# CITY OF SAN ANTONIO POADP APPLICATION

Re: Los Caminos

POADP # 704

The City Staff Development Review Committee has reviewed Los Caminos Subdivision Preliminary Overall Area Development Plan # 704. Please find enclosed a signed copy for your files. Your plan was accepted however please note the following:

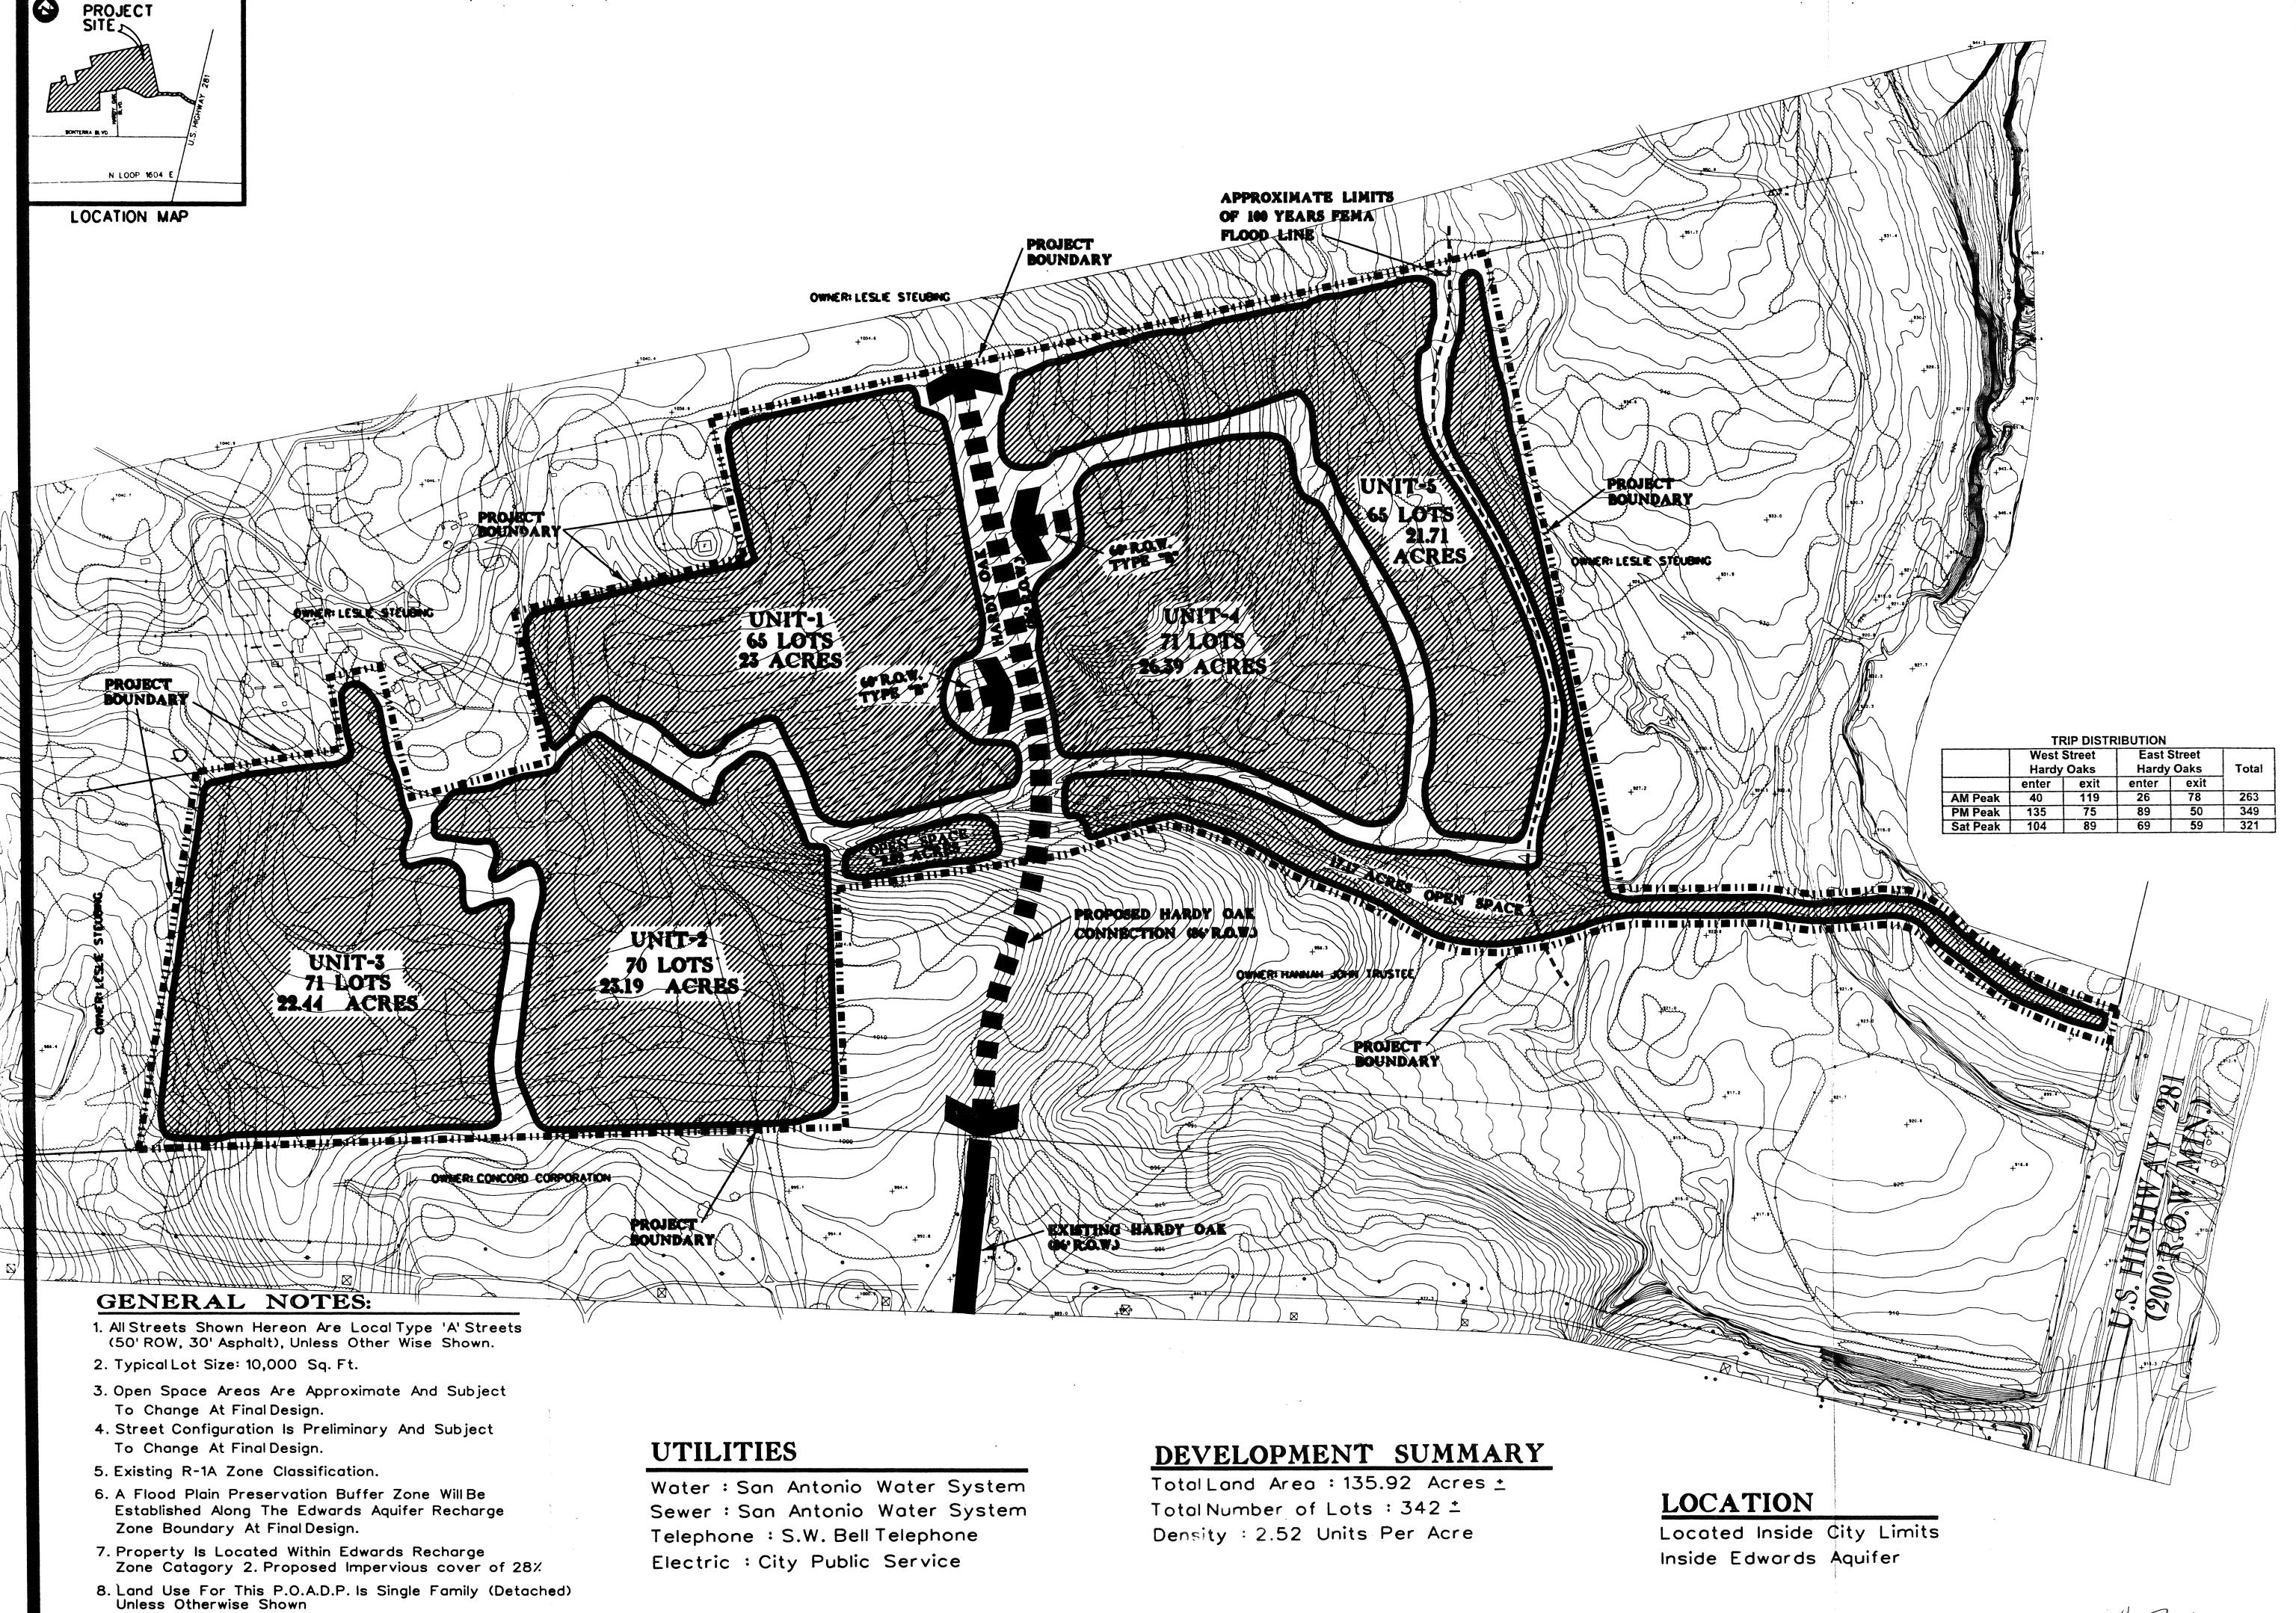
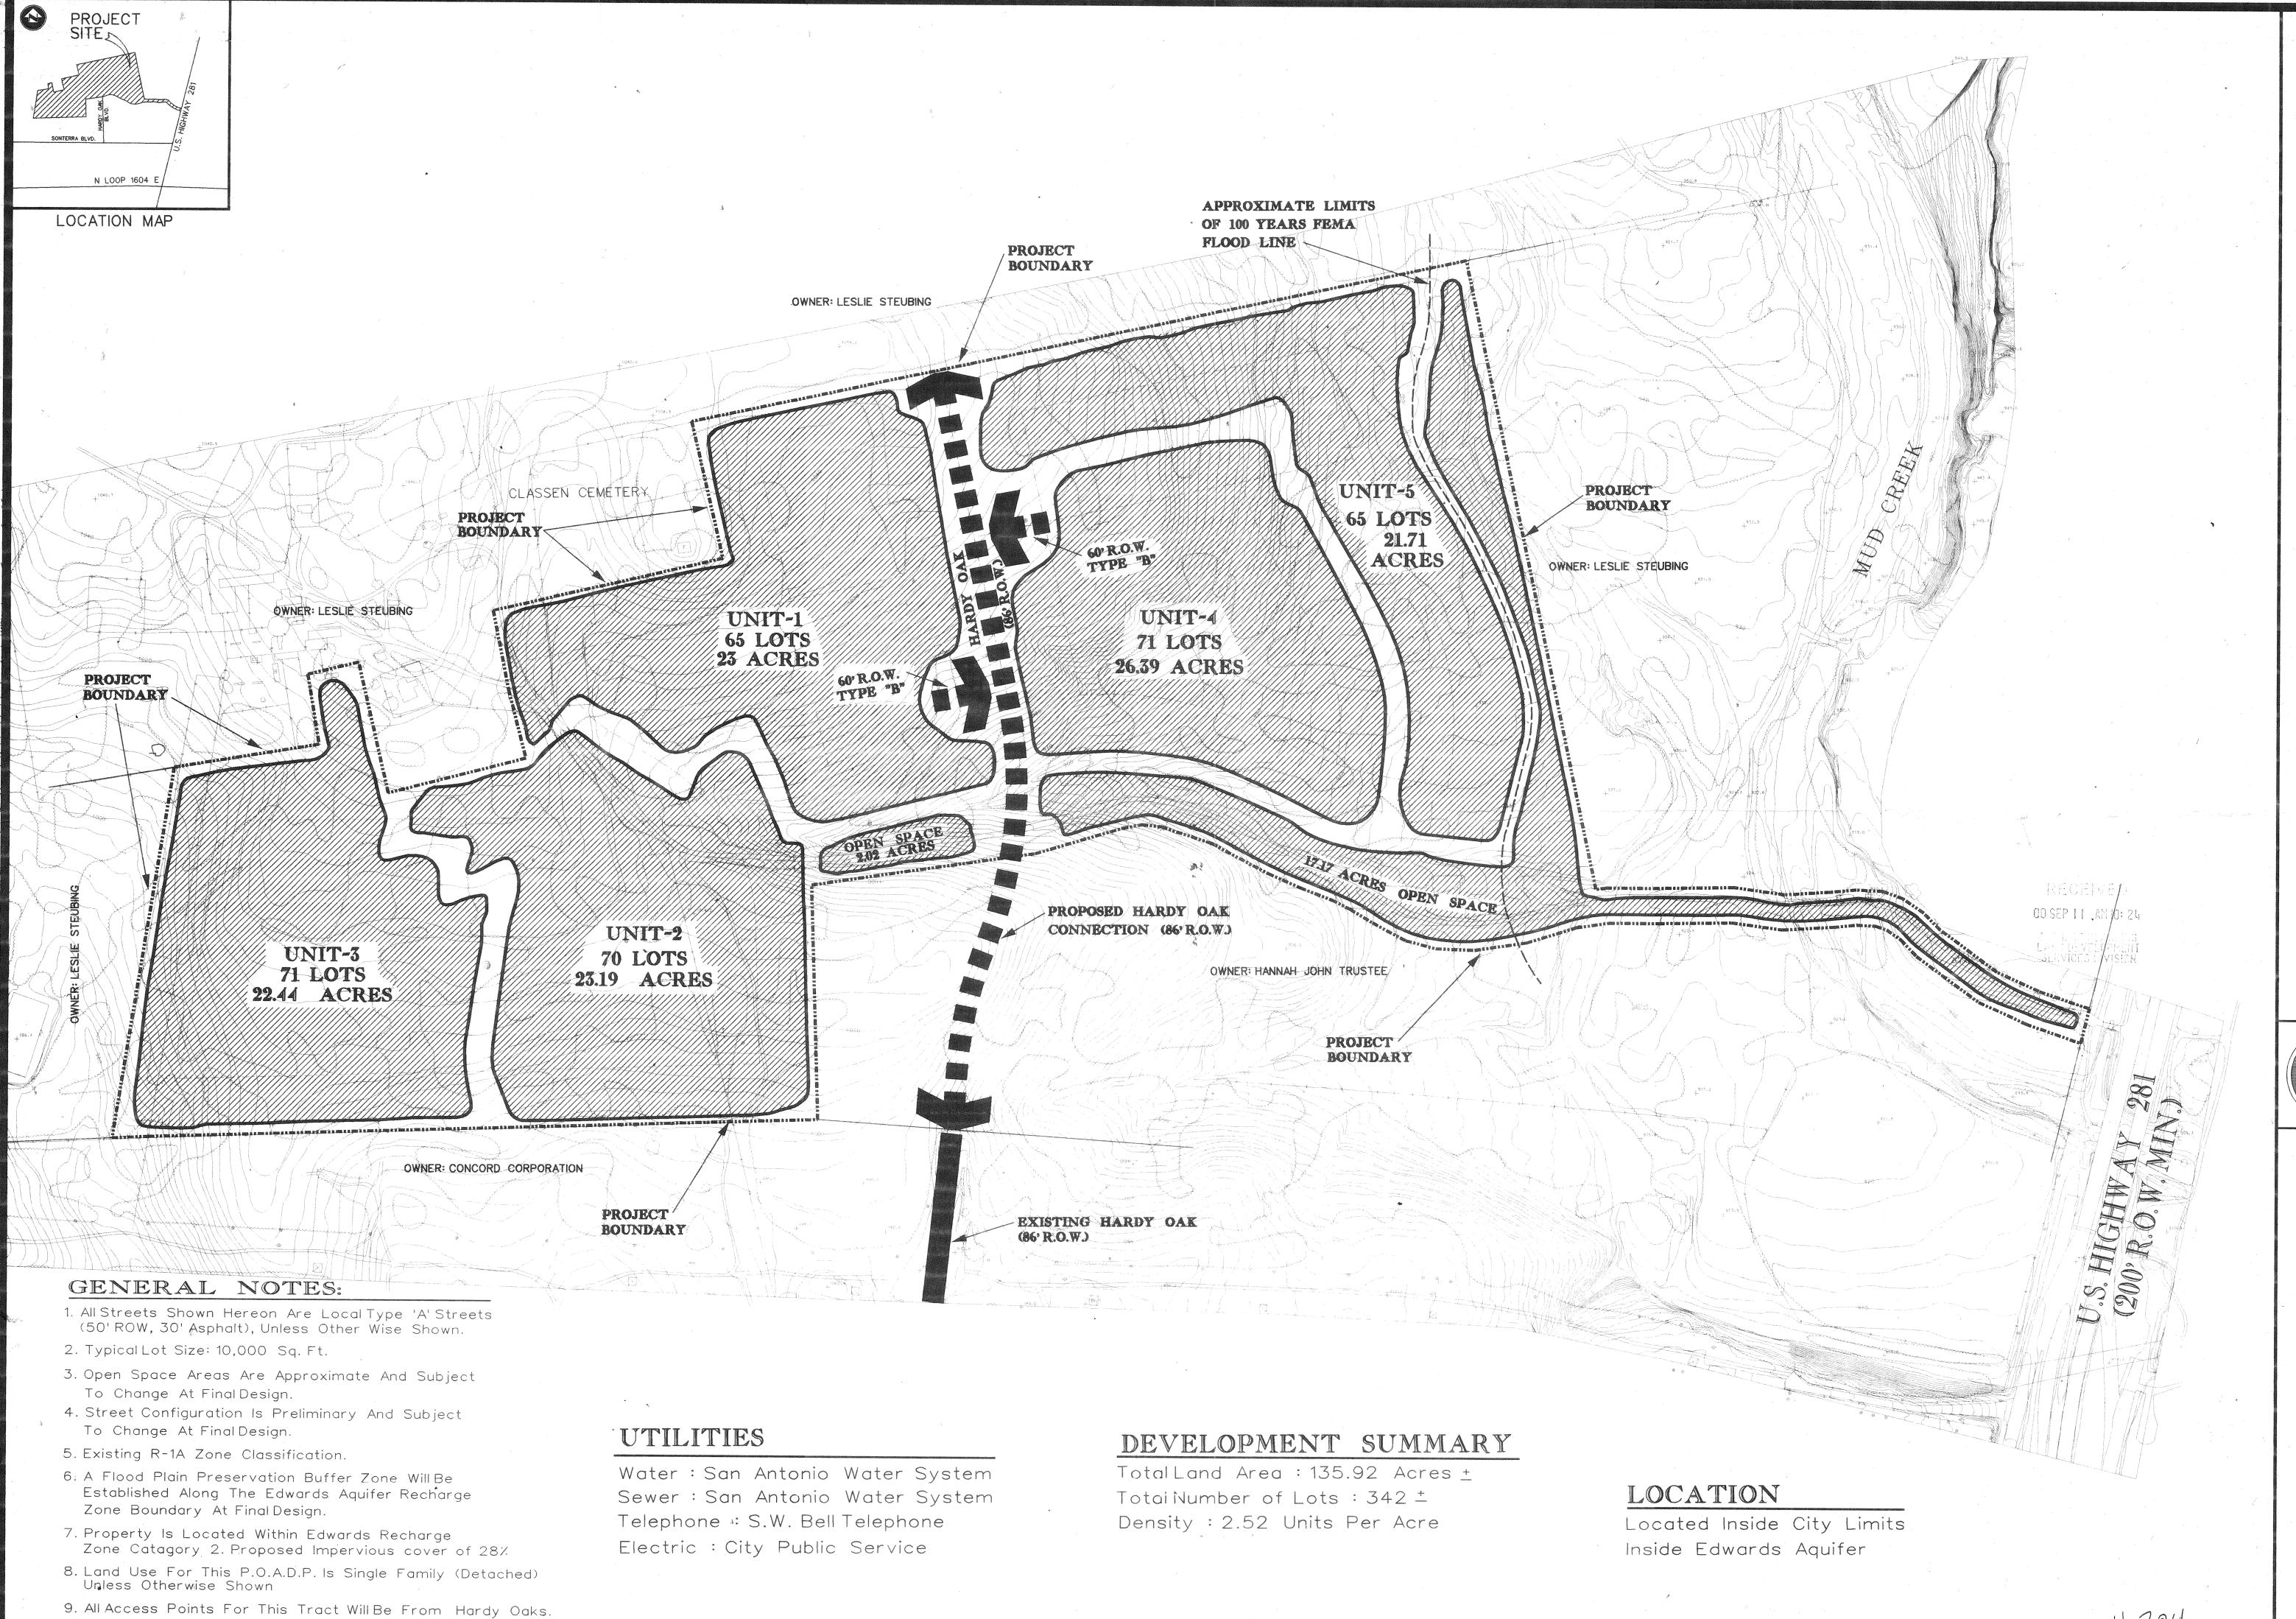
- 1.) Sec. 35-2075 Information Required
- (a) Huebner Rd R.O.W. needs to be shown on the proposed P.O.A.D.P.
- (c) City Arborist approval is missing.
- (d) Show current zoning on P.O.A.D.P.
- (i) One hundred-year floodplain limits was not identified on plan.
- 2.) Sec. 35-4110 Access From Major Thoroughfares
- (a) It appears that Hardy Oaks Rd. and Huebner Rd. intersect at this site, both will have to be shown with the required 86' R.O.W.s.
- d) Paragh, (2) The resulting additional ingress and egress of vehicles will seriously disrupt the flow of traffic on the thoroughfare. A 1'-non accesses esm't will be required on the properties adjacent to the proposed collectors.
- 3.) Access needs to be provided to the adjoining properties for connectivity.
- 4.) An approved T.I.A. will be required.

(a) Huebner Rd is on the Major Thoroughfare with a proposed 86' R.O.W. The northern edge of this site needs to show half of the required R.O.W (43').

- (a) Hardy Oaks Rd. and Huebner Rd. intersect at this site, both will have to be shown with the required 86' R.O.W.s.
- d) Paragh, (2) The resulting additional ingress and egress of vehicles will seriously disrupt the flow of traffic on the thoroughfare. A 1'-non accesses esm't will be required on the properties adjacent to the proposed Major Thoroughfare.
- 3.) Redland Rd. is proposed by Tx-Dot to connect to Huebner Rd Please show this alignment and how it will affect the northern part of your property as per our discussion.

9. All Access Points For This Tract Will Be From Hardy Oaks.

10. A One Foot Non Access Easement Will Be Placed On Lots
